PLAN AND SPECIFICATION QUESTIONS

Project Name: Vibra Bismarck Rehabilitation Hospital
Architect: EAPC
Bid Date: February 19, 2025

1 S201 FOUNDATION/FIRST FLOOR SLAB PLAN
1/8" = 1'-0"

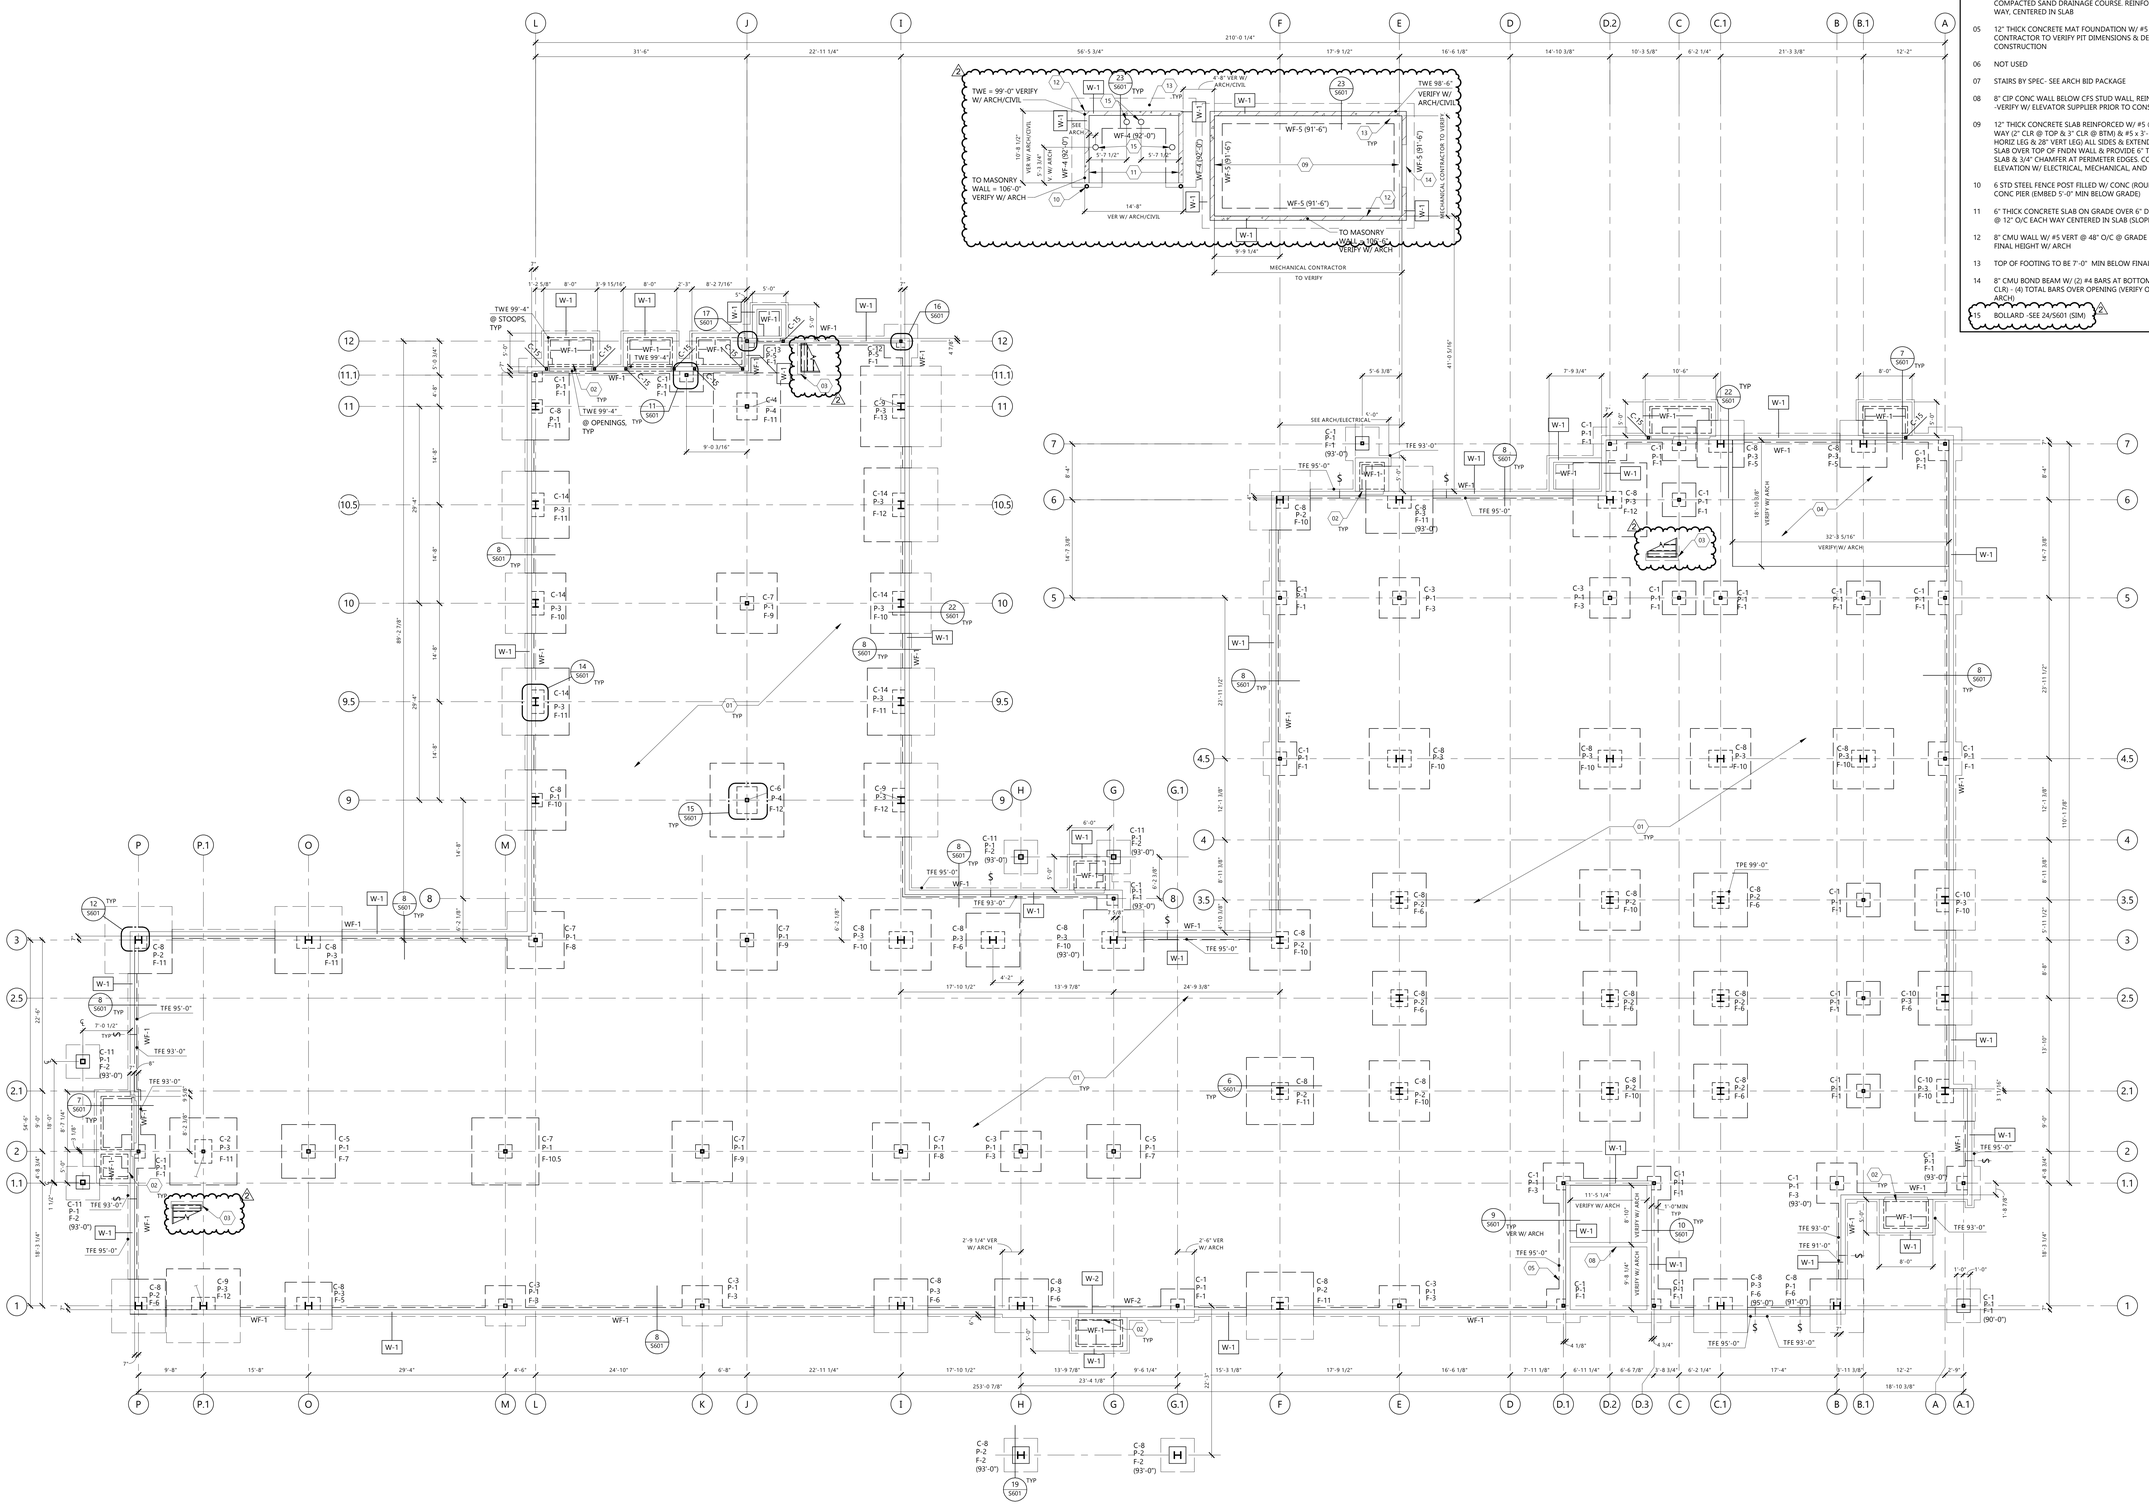
Question#	Plan Sheet / Specification	Date of Question	Question	Answer
1	Keynote 3, S201	1/30/2026	Keynote 3 on S201 indicates to provide " 12" THICK x 48" WIDE x STAIR WIDTH THICKENED SLAB @ STAIR LANDING W/ (3) #5 BARS CONT @ BTM". Should there be anchor bolts at the bottom of these stairs to catch the stringers/embed plate? No further information was provided for these stairs in this bid package. Please also provide dimensions off of gridlines for the location of these thickened slabs.	Most likely yes, as part of the delegated stair design. We sometimes add a detail and if needed and copy/check 14/S601 for 20237800. Location is to be GC verified and coordinated with delegated stair designer/fabricator.
2	Keynote P7 / C4.0	1/30/2026	Are sidewalks shown on drawings supposed to be reinforced? No reinforcing can be found in details.	Sidewalk is to be unreinforced other than tied to back of adjacent curb as noted in curb detail.

19	S201, 4/A003, C4.0	1/30/2026	Between sheet S201, A003, and C4.0, no information can be found regarding the elevation of the Generator Pad, Dumpster Pad, and Bulk Oxygen Tank Pad. Please provide this information.	STRUCTURAL: Elevations are noted to coordinate with others; civil shall verfy elevations such that they fit with site grading / CIVIL???
20	Electrical, Spec Section 26 3213; Part 2; Section 2.05; Subsection C	1/30/2026	Spec Section 26 3213; Part 2; Section 2.05; Subsection C indicates to provide a wall-mount remote annunciator for the generator. Where is this to be located? Should there be multiple annunciator panels?	This is currently located at nurse station 1016
21	E100	1/30/2026	Sheet E100 shows parking spaces where the Generator Pad and Bulk Oxygen Tank are located. Can this be corrected?	Civil and Structural, whose bid packages are responsible for this scope of work, are correct and govern. Electrical background will be updated in a future issuance.

1 S501 MED GAS ENCLOSURE ENLARGED FOUNDATION/FIRST FLOOR SLAB PLAN
1/4" = 1'-0"

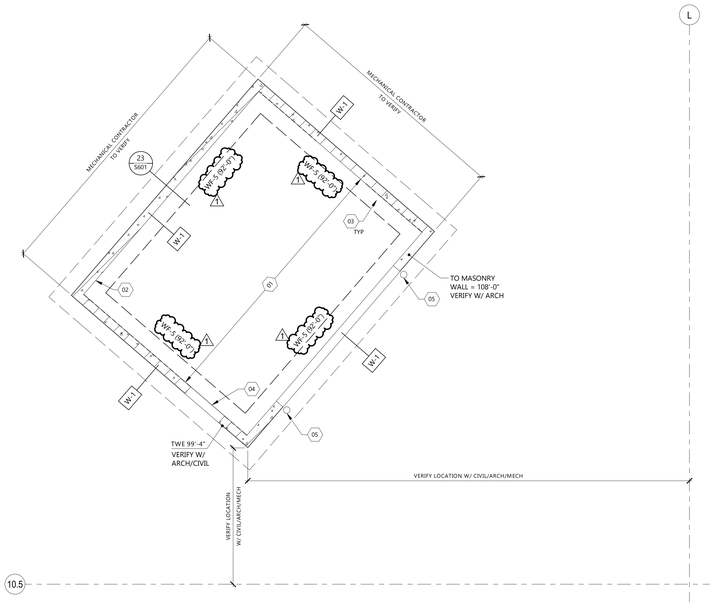
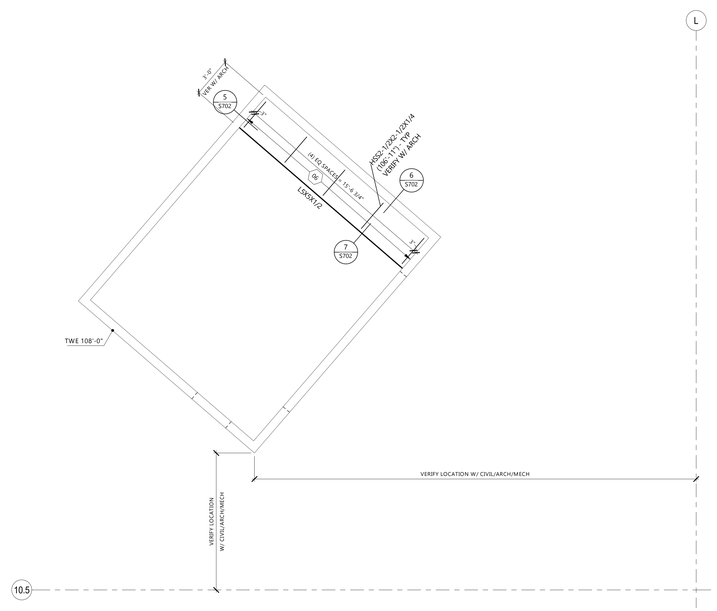
42	A003 / S201 / C4.0 / S501	1/30/2026	Sheet S201 and S501 indicates the measurements of the medical gas tank pad as "MECHANICAL CONTRACTOR TO VERIFY", however dimensions are provided on sheet A003 and S501. Are the measurements on A003 matching the vendors requirements? Finally, please confirm what grade the pad is to be set at. No grade can be found on sheet C4.0. Is this supposed to be set at top of curb elevation? Is the curb supposed to drop on each side of the pad and be flat across the entrance of the pad? Please provide further information and the vendors drawings for use.	5/A003 contains dimension consistent with specified tank. Mechanical contractor to verify with final approved equipment shop drawings prior to install as stated on the document. DUPLICATE QUESTION TO 19
43	C4.0 / S201 / A201	1/30/2026	Sheet S201 and A201 indicate a stoop outside of door 1040B on the West side of 1040-DAY ROOM, however C4.0 does not show any concrete sidewalks/pavement connecting to this stoop, should concrete sidewalks be provided here?	No. Not a means of egress.

3 A003 SITE PLAN
1" = 20'-0"

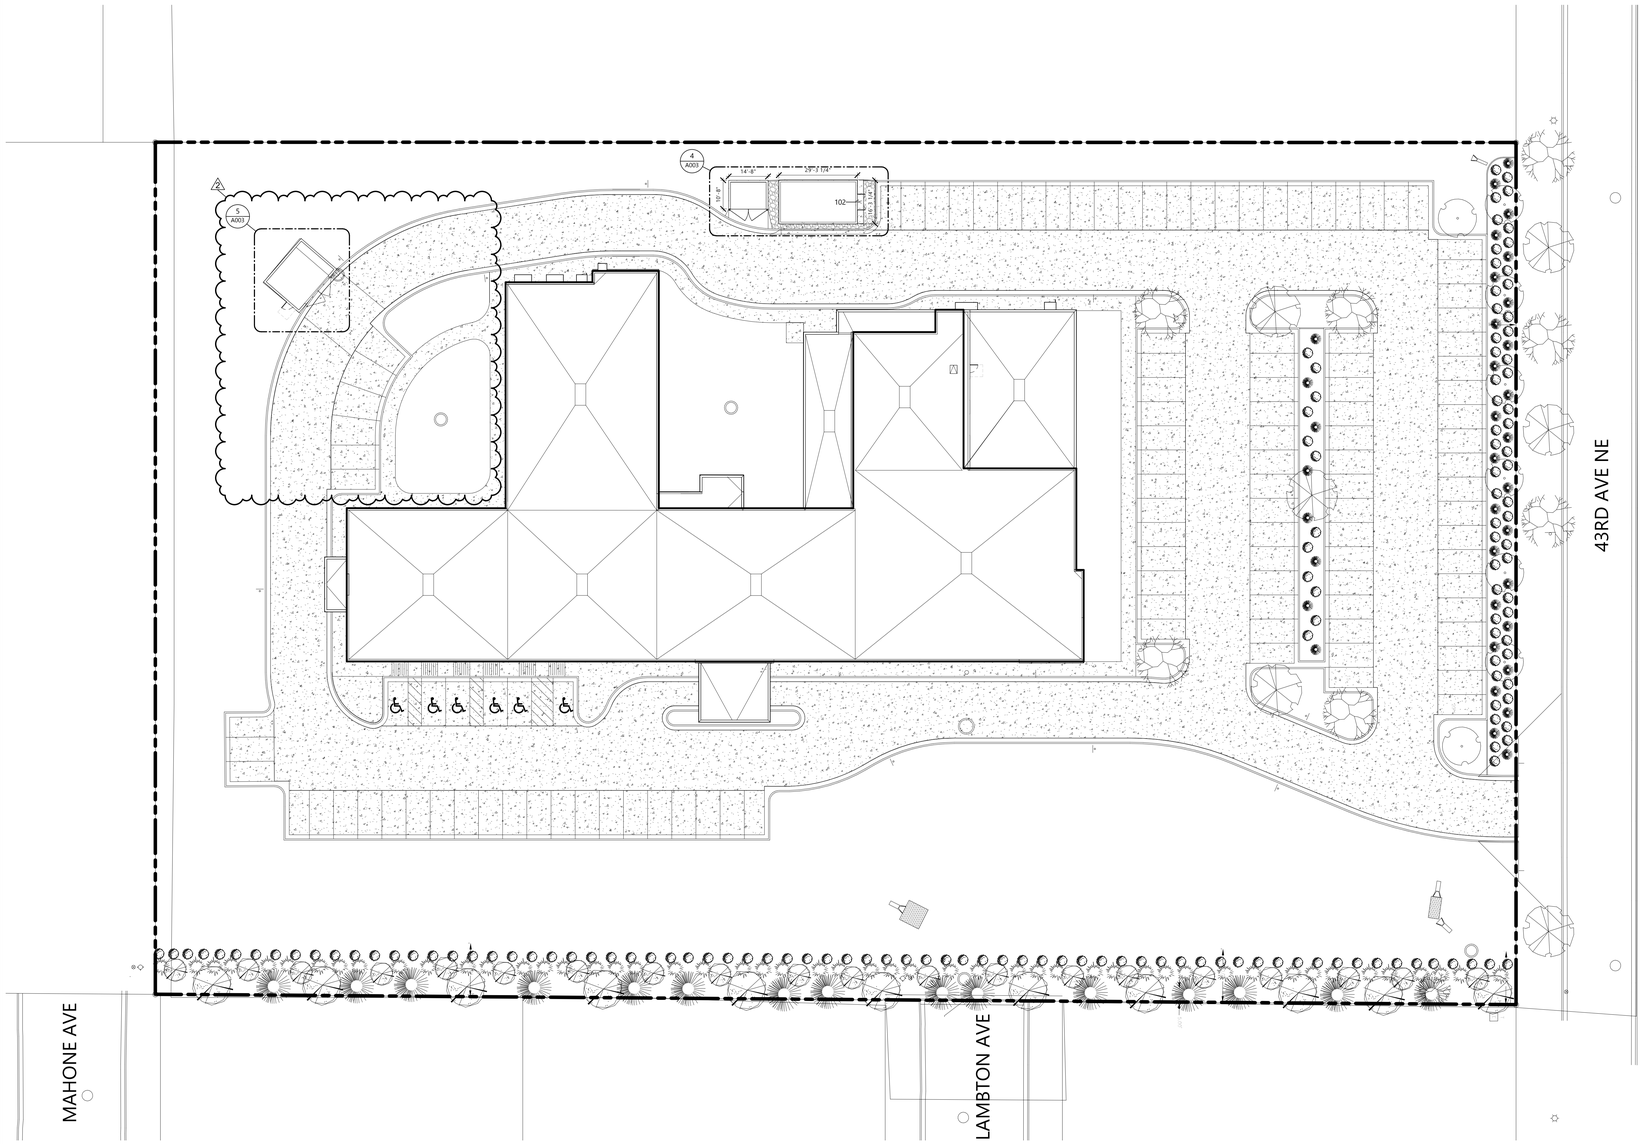
- 2/A003 Added – Note for concrete Pier.
- 3/A003 Revise - Parking and drive around med gas enclosure.
- 5/A003 Added – Keynote AS02 for metal roofing over equipment.
- A021 – RA1 Revise – RA1 ½" Glass mat fire resistant type
- 12/A504 Added – Detail in its entirety.
- A801 Removed – Unused glazing types.
- A802 Removed – Unused glazing types.
- 12/A802 Revised – Glazing type to G-2
- P200 Added – irrigation stub out.
  Removed – 1" water service.
- 6/P401 Added – irrigation piping and rpz.
- 1/P801 Added - irrigation stub out

1 A504 KITCHEN ENLARGED PLAN
1/4" = 1'-0"

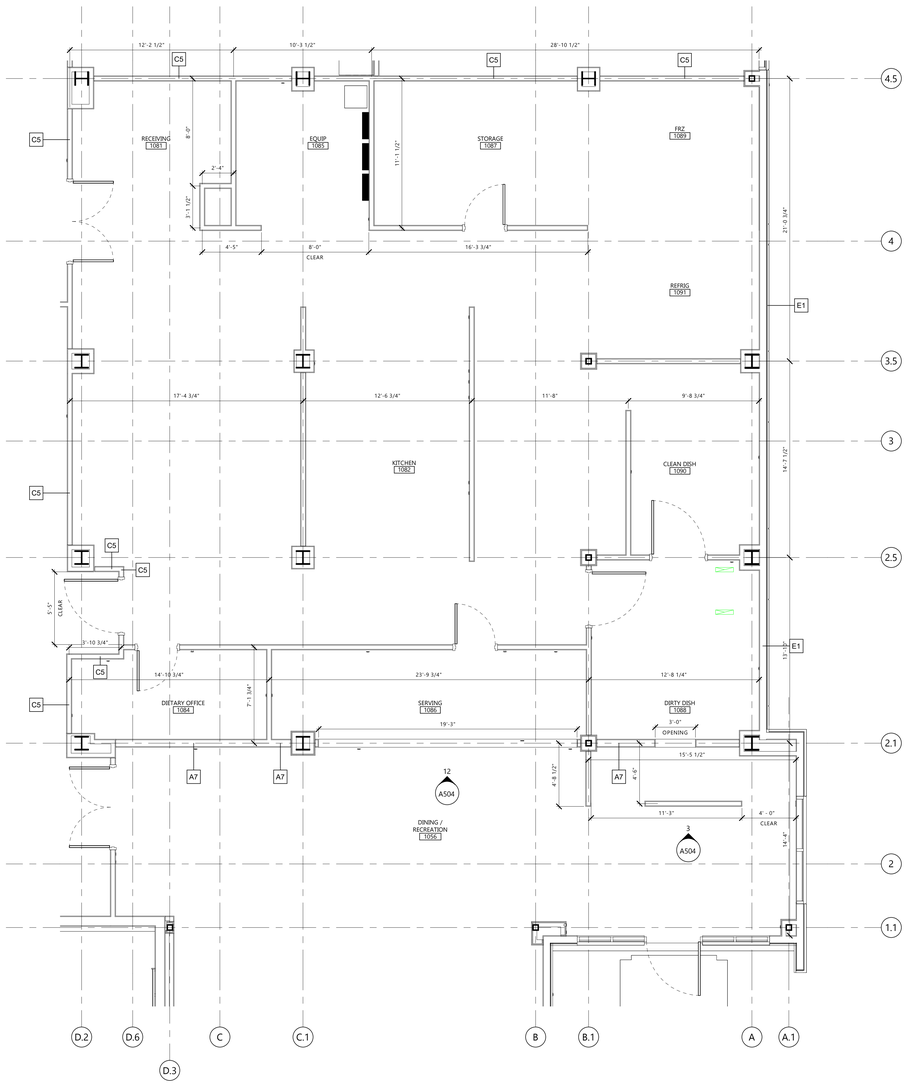
31	A504	1/30/2026	Detail 1/A504 indicates an opening between the 1088-Dirty Dish and the 1056 - Dining/Recreation area, but no elevations or further details are provided for this opening. What is this opening to be comprised of? Is there a solid top that acts as a surface between the two rooms? Please provide further details regarding this passthru.	The pass-through window is a complete stainless steel assembly provided and installed by Baring Foodservice as item 33A on the issued kitchen equipment drawings. Provide a 3'-0" x 3'-0" rough opening above kitchen counter backsplash.
32	07 2400; Part 2; Section 2.2; Para A and 07 2500; Part 2; Section 2.1	1/30/2026	As described in spec section 07 2400; Part 2; Section 2.1; Para A, the EIFS system basis of design is "Dryvit Outsulation X EIFS, Class PB with Moisture Drainage: www.dryvit.com/#sle.", and further in section 2.2; Para A states " Exterior Insulation and Finish System: DRAINAGE type; reinforced finish coating on mechanically-fastened insulation board over sheet-type combination drainage layer/water-resistive barrier over substrate; provide a complete system that has been tested to showcompliance with the following characteristics; ", when reviewing Dryvit's website, this appears to be an entire system with integrated fluid applied weather barrier/drainage layer, insulation, mesh, and first/finish coats. Further, spec section 07 2500; Part 2; Section 2.1 indicates a fluid applied weather barrier system. Is that the intent to have a weather barrier system provided with the basis of design EIFS system, or is the intent to have a weather barrier separate from the basis of design EIFS system? Please clarify the intent of these systems and interaction.	Provide and install per Dryvit manufacturer system, assembly, and installation standards.

1 A901.B FIRST FLOOR FINISH PLAN AREA B
3/16" = 1'-0"

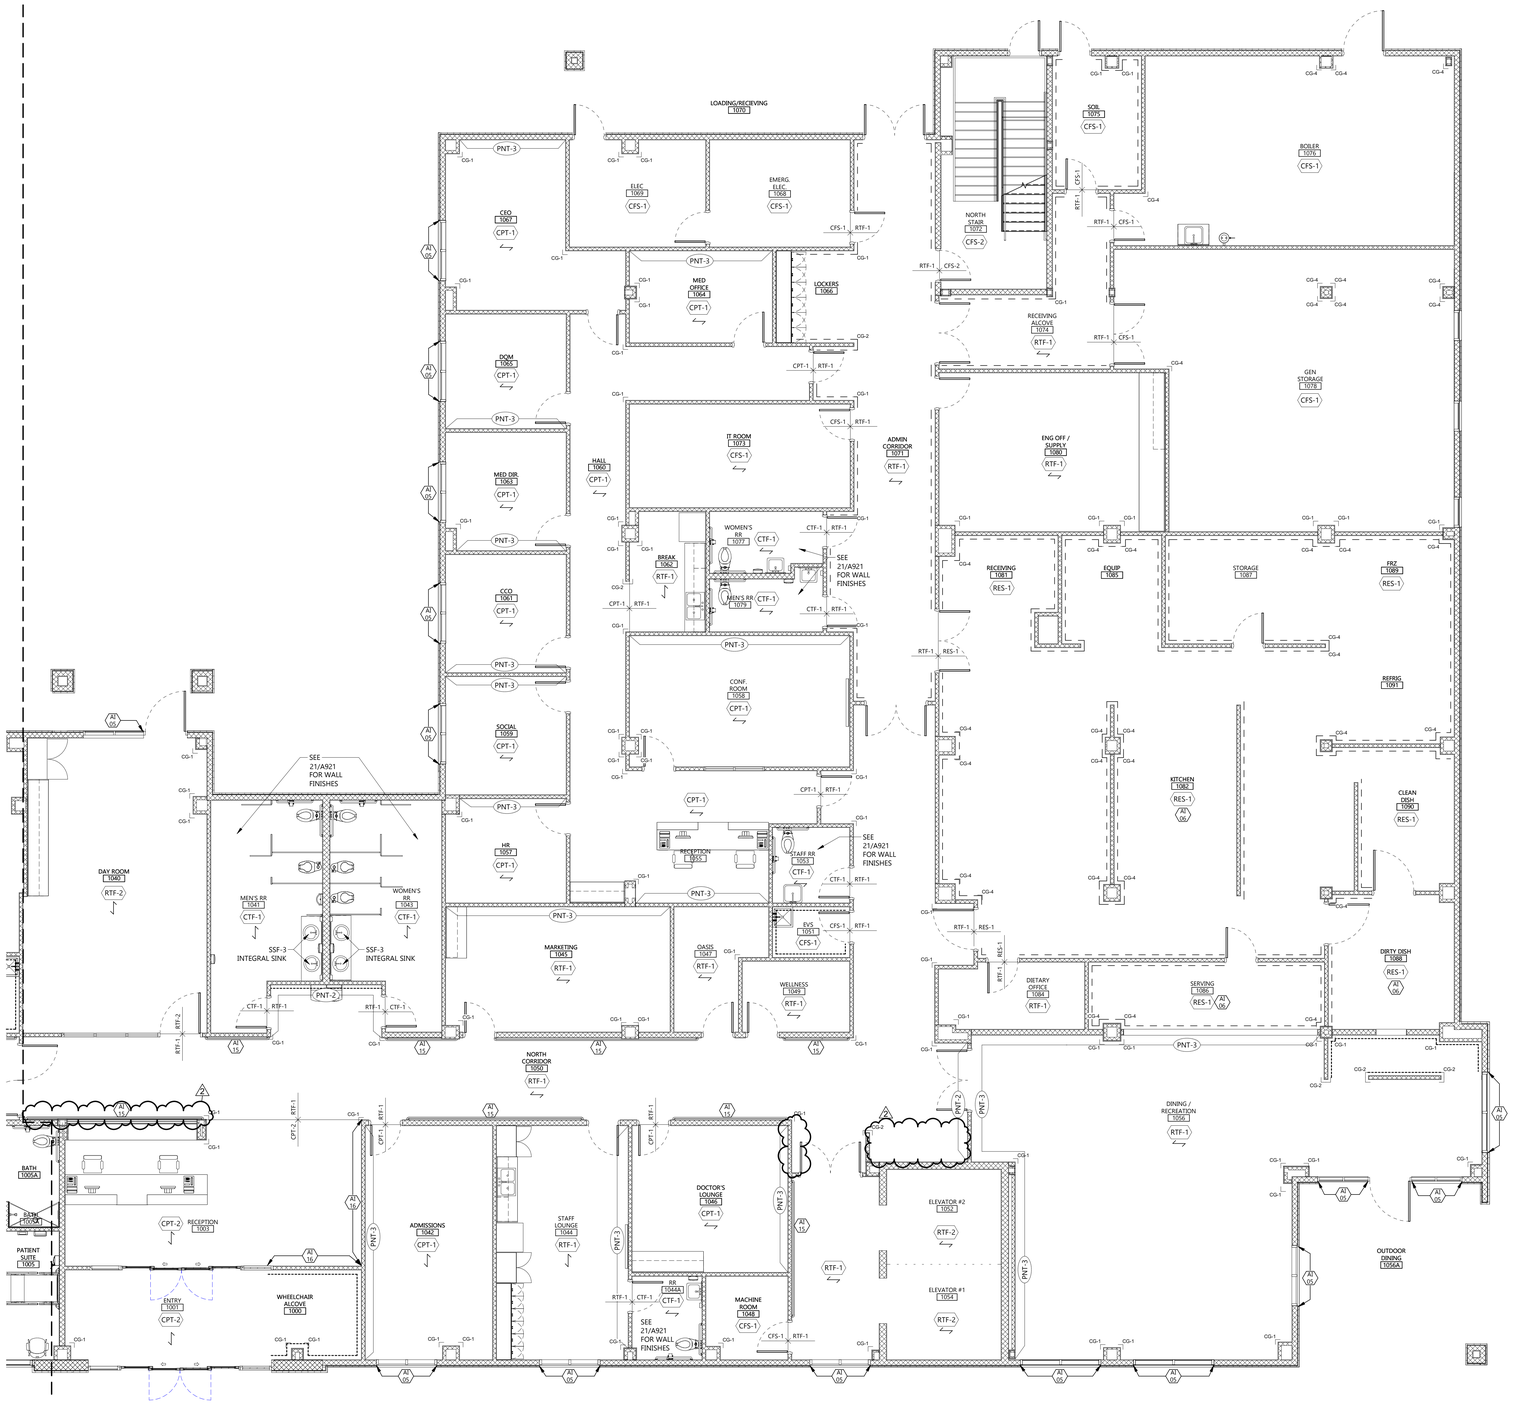
51	A901.B	1/30/2026	Sheet A901.B indicates "AI16" in the 1003-RECEPTION AREA and indicates "ALTERNATE: PROVIDE PRICING FOR WOOD PANEL WALLCOVERING IN LIEU OF PAINT.". Is this considered a contract alternate? What "WOOD PANEL WALLCOVERING" is to be priced? Should this be priced floor to ceiling height? Please provide these details and elevation views, along with a product and applicable specification section for the alternate.	Yes a contract alternate. Priced floor to ceiling. Will provide any detail drawings and specifications.
52	A921, 12 2400, A301, A302, A901.A, A901.B, A902.A, A902.B	1/30/2026	Sheet A921 indicates "RS-1", but does not clarify if RS-1 is a manual or motorized shade. Specification section 12 2400 indicates both manual and motorized shades, but further indicates the basis of design under section 2.2, subsection B as MANUAL, and section 2.2; Subsection C as MOTORIZED. Which this correct? Additionally, what type and size of shade facia is to be provided? Finally, detail 3/A821 indicates "WINDOW TREATMENT WHERE APPLICABLE - SEE RCP FOR TYPE AND LOCATION", however no shades / notes related to shades are indicated on sheets A301 and A302. Is this detail supposed to reference A901.A, A901.B, A902.A, and A902.B where keynote "AI05" is indicated ?	Manual roller shades please. AI05 is indicated on A901.A, A901.B, A902.A, A902.B. Dual roller facia, per manufacturers requirements to conceal the shade mounting.
